BCA REPORT
Preliminary Review

GOULBURN PERFORMING ARTS CENTRE

Revision: 0
Date: 12 August 2016
Project No.: 160301

Figure 2: Option showing non-EV Part fire separated from EV

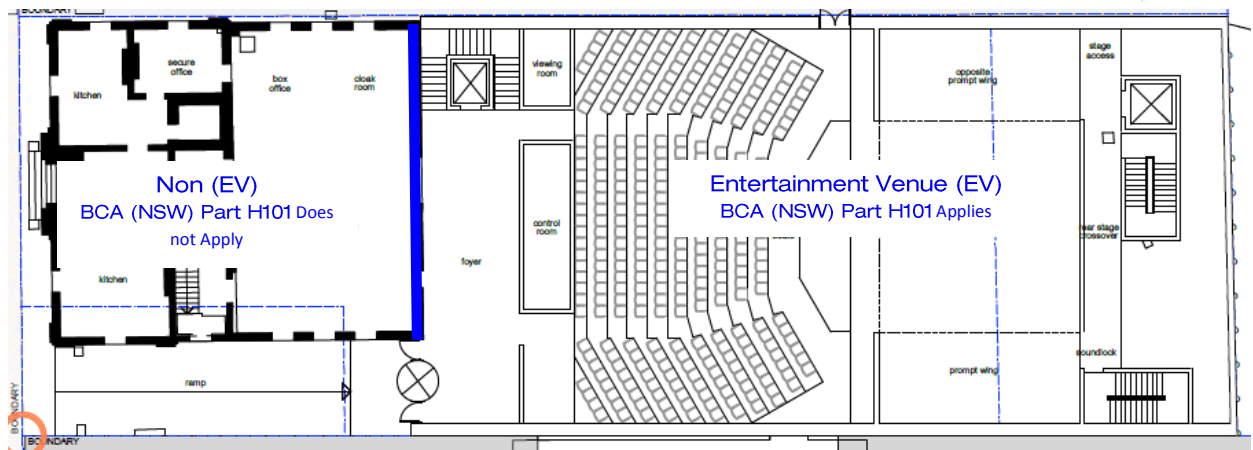
3. The building is deemed an Entertainment Venue (EV) and therefore subject to compliance with BCA (NSW) Part H101 provisions. These provisions include requirements above and beyond the BCA national provisions, such as 1m clear width for all doors used by the public, all swinging doors must swing in the direction of egress, fire separation of storerooms, etc.

The above provisions will need to be applied to the whole building; however where areas such as the the existing building part are fire separated from the remainder of the building by construction achieving 60/60/60 FRL, then provisions of BCA (NSW) Part H101 need not be applied to the non-EV fire separated part. An example is provided below in Figure 2.

Figure 2a: Location of Fire Walls

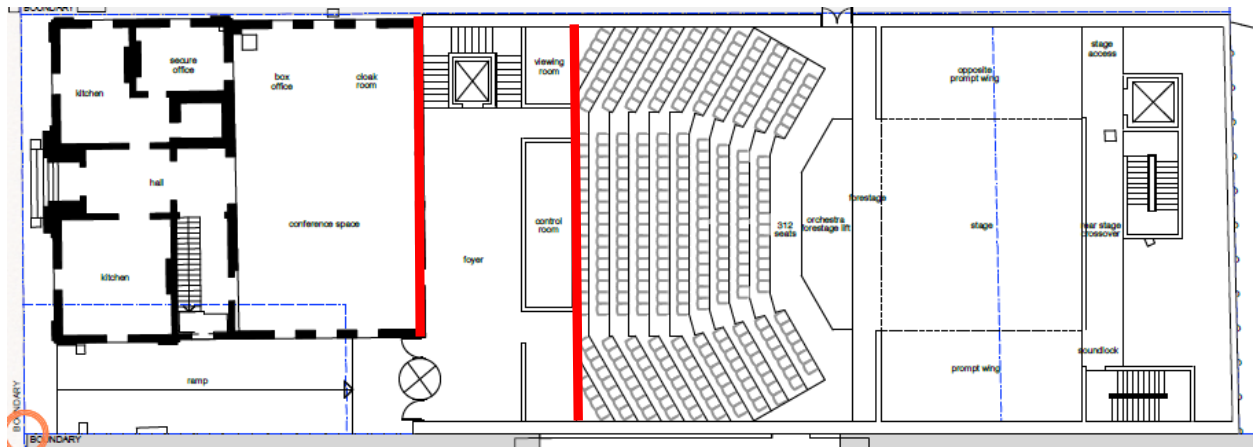
4. Having regard to fire compartmentation within the building, we note that 2hr fire walls will be required between the existing and new building parts and between the auditorium and the lobby, as indicated below:

There may be opportunity to reduce the FRL of the fire walls located between the existing and new building parts subject to a fire engineered Alternative Solution based upon the installation of the sprinkler system.

Figure 3: Boundary locations

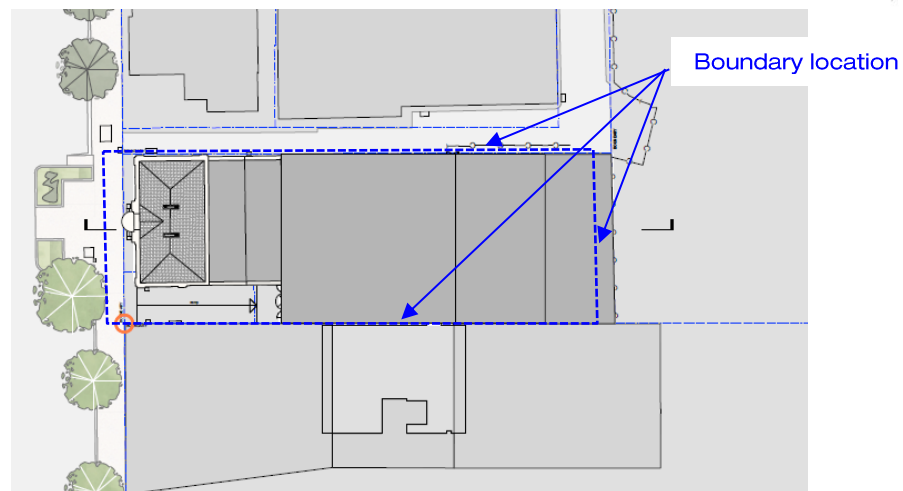
10. Based upon the site plan, it appears that the existing and proposed parts of the building are located directly adjacent to the site boundaries, being the Fire Source Feature. As such the external walls will typically need to be fire rated to achieve not less than 2hrs, whilst any openings located within the elevations that are less than 3m from the subject boundary line will need to be protected.

Further verification will need to be provided having regard to the building setback from the site boundaries along with verification of the parcel of land located to the North East of the site and whether rights to this land is permitted via easements or the like.

Figure 4: Single exit non compliance - Mezzanine

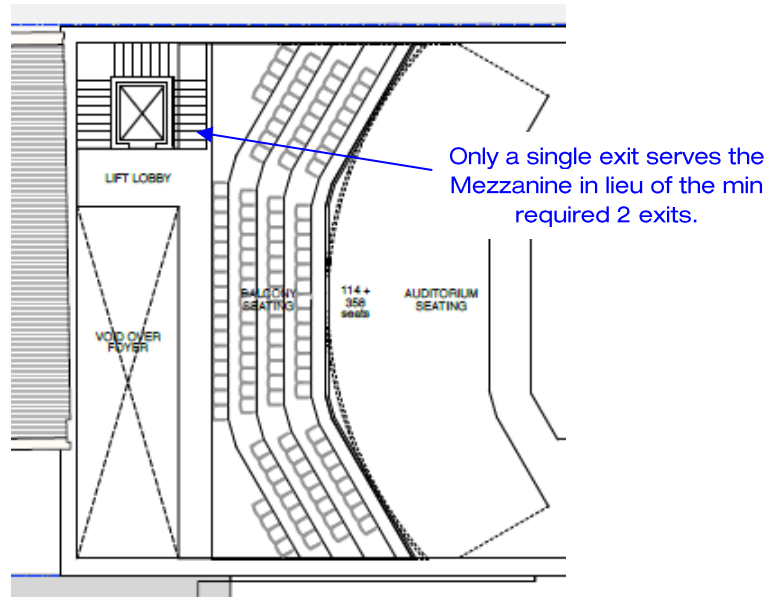
1. In a Class 9b building that can accommodate more than 50 persons, must be provided with not less than 2 exits. In this regard, we note that there appears to be only a single exit serving the Mezzanine level, in lieu of the minimum required 2.

Please note that there may be opportunity to provide an Alternative solution for the single exit to the mezzanine, providing the egress width accommodates the population (approx. 3m wide), sprinklers installed and smoke exhaust is provided above this area.

Figure 5: Single exit non compliance – Basement Level

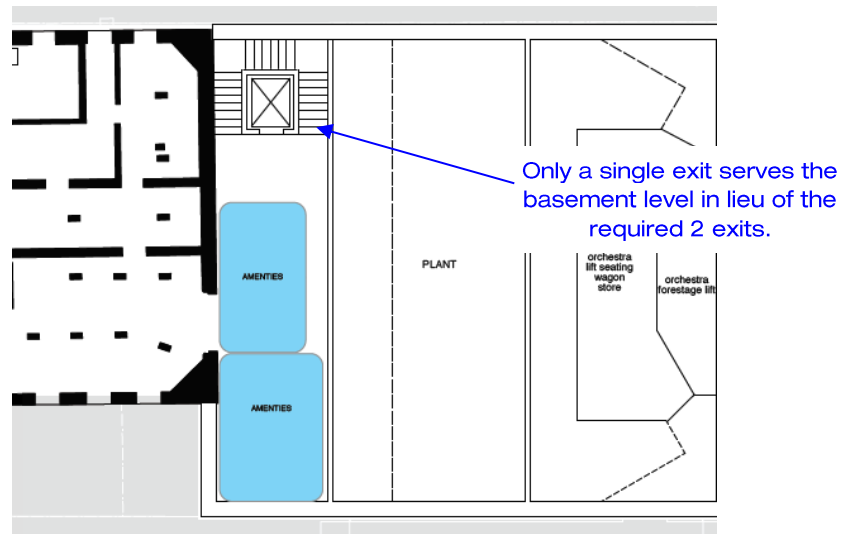
In addition to the above, we note that where travel from a storey involves the vertical rise within the building of more than 1.5m, where the floor area is greater than 50m², then two exits must be provided. In this regard we note that travel from the basement level amenities is served by a single exit rather than the minimum required 2 exits.
